## ECO Plus 3 axle for tire pressure control systems

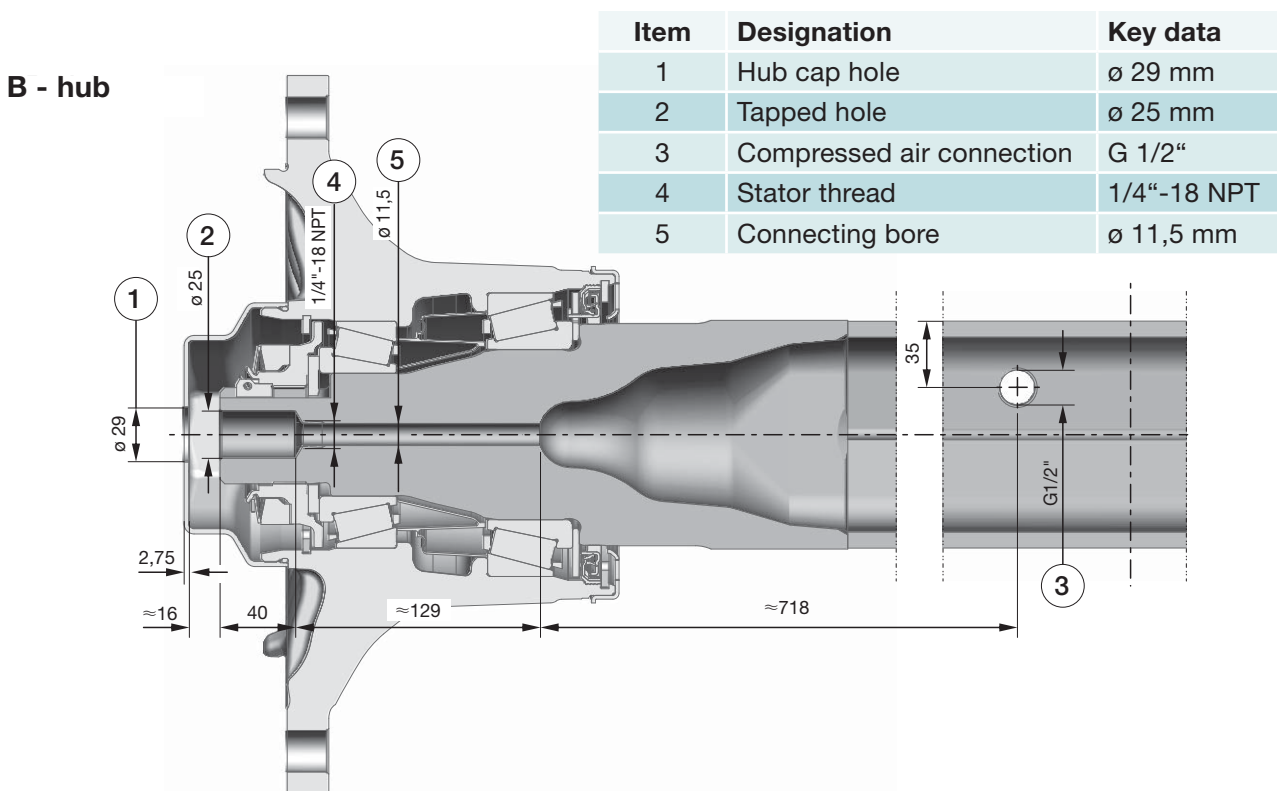
With immediate effect, BPW is adding a 9 t ECO Plus 3 axle to its product range that is prepared for the installation of a tire pressure control system. The axle is available for wheels with ET 0 and ET 120 offset. In preparation for installation of a tire pressure control system, the axle beam and hub cap have been prepared with access holes and tapped threads where necessary.

The axle is supplied with a standard hub cap to protect the bearing against moisture. The drilled hub cap intended for installation is also supplied as a separate item.

The positioning of the connections between the axle and the tyre pressure control system must be coordinated directly with the system vendor. BPW has matched with Eurocolven (Vigia) and PSI the positioning of the connections between the axle and the tire pressure control system. The drawing shows the precise dimensions of the access holes and connections.
